Alert Service Bulletin No. 224

Alternator Spacer P/N 41151 Inspection

- (1) Hartzell Engine Tech has discovered that affected alternators may have been shipped with an incorrect spacer.

Figure-1 - Spacer Inspection

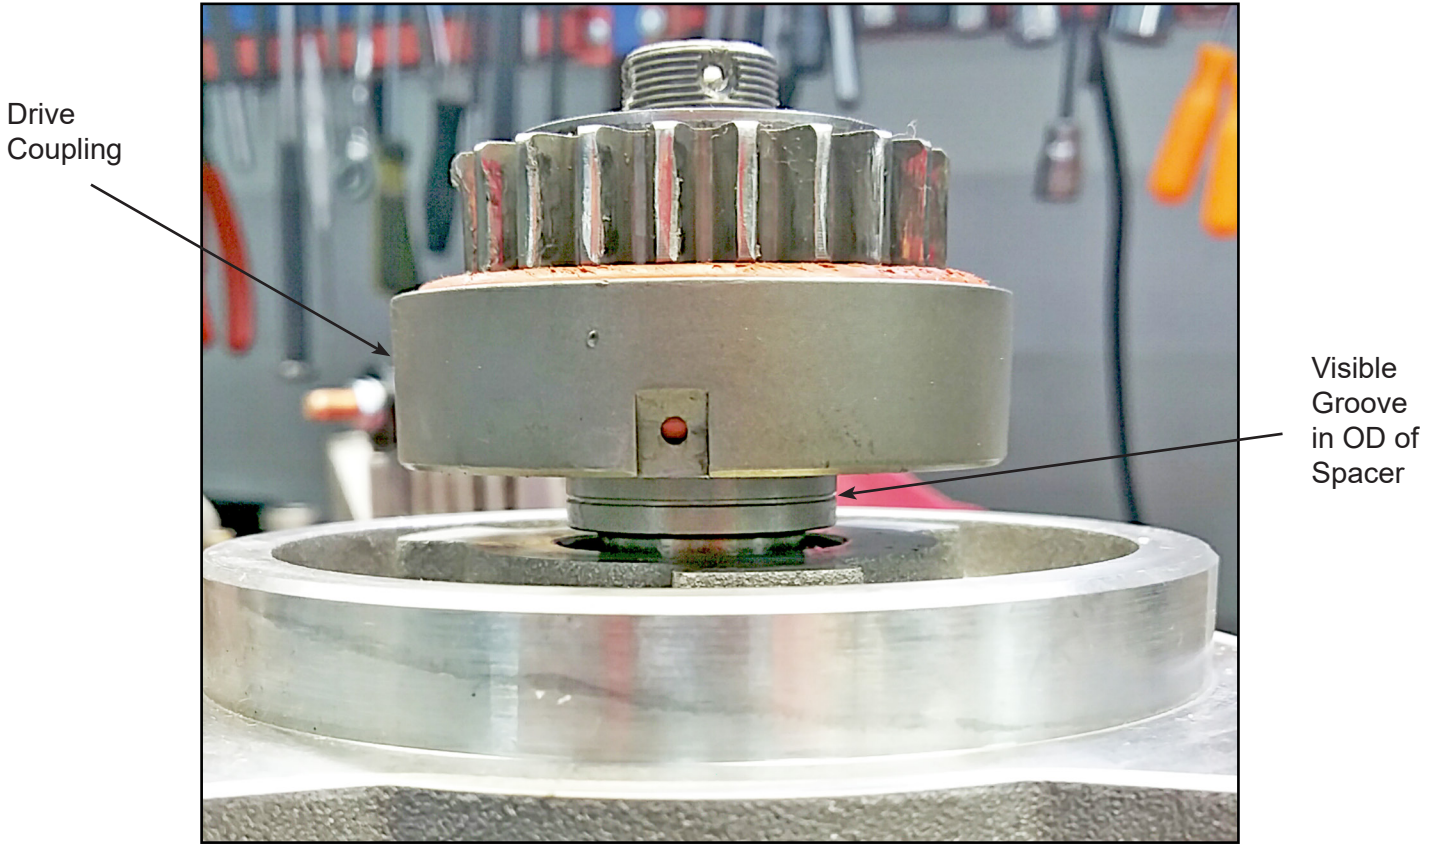
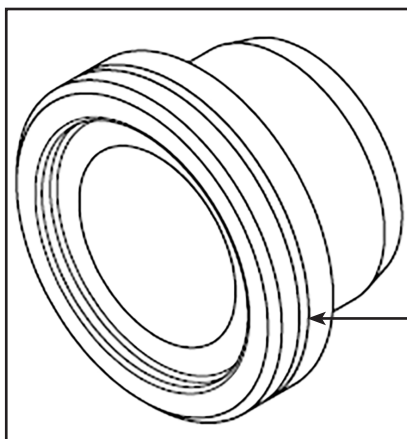
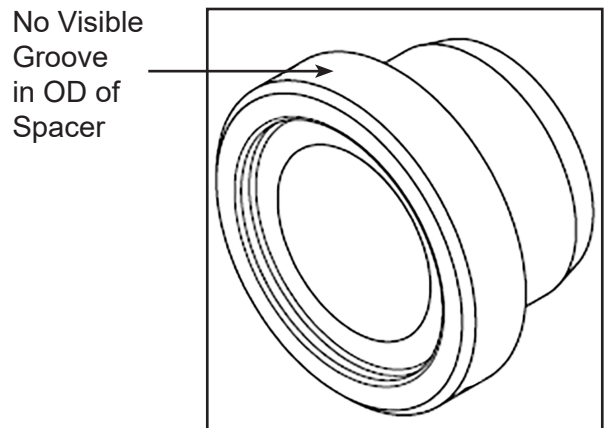
- (a) Remove the affected alternator in accordance with applicable aircraft engine and airframe service instructions or maintenance manual.
- (b) Using a flashlight, visually inspect the spacer between the alternator and alternator drive coupling. Refer to Fig. 1 thru Fig. 1b
 - 1) If the spacer **does** have a visible groove in the OD as shown in Fig. 1, no further maintenance is required.
 - a) Install the alternator in accordance with applicable aircraft engine and airframe service instructions or maintenance manual. Continue to 3C. Return to Service.
 - 2) If the spacer **does not** have a visible groove in the OD as shown in Fig. 1, replace the spacer in accordance with below instructions, 3 B. (2).

Figure-2 - Spacer Replacement

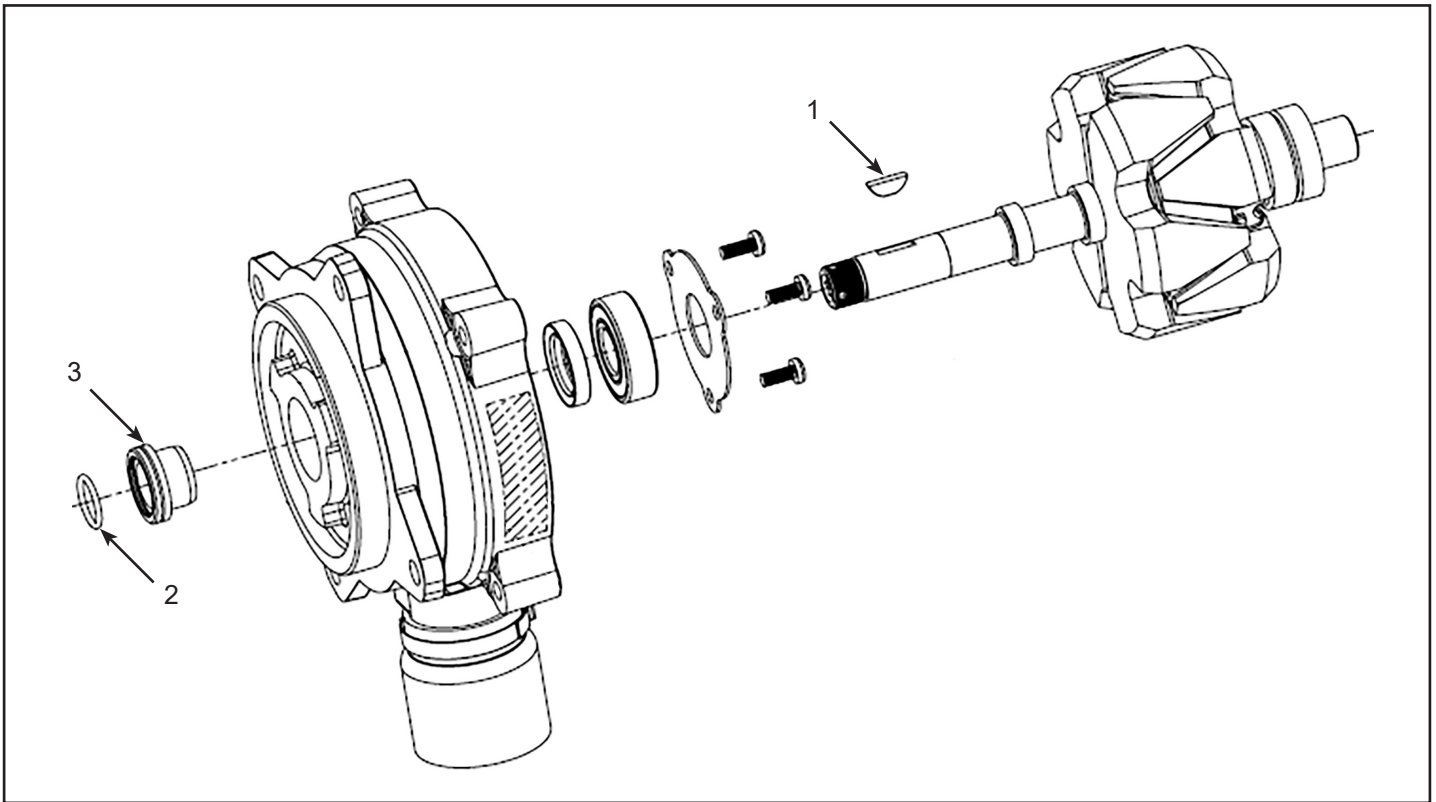
- 5) Remove and discard O-Ring (2) from rotor assembly drive shaft.
- 6) Remove and discard spacer (3) from the alternator drive-end housing and rotor assembly drive shaft.

- 1) Insert a new spacer (3) P/N 41151 onto the rotor assembly drive shaft and into the drive-end housing.
- 2) Lubricate a new O-Ring (2) with Dow Corning® Molykote 111 Compound and install the O-Ring onto the rotor assembly drive shaft and against the spacer (3).
- 3) Install the woodruff key (1) into the rotor assembly drive shaft.
- 4) Install the alternator drive coupling and new thrust washer in accordance with Continental Aerospace Technologies' M-0 Manual, § 10-4.1.3.
- 5) Install the alternator onto the engine in accordance with applicable aircraft engine and airframe service instructions or maintenance manual.
- 6) Perform an engine oil change in accordance with applicable aircraft engine and airframe service instructions or maintenance manual. Continue to 3. C., Return to Service.
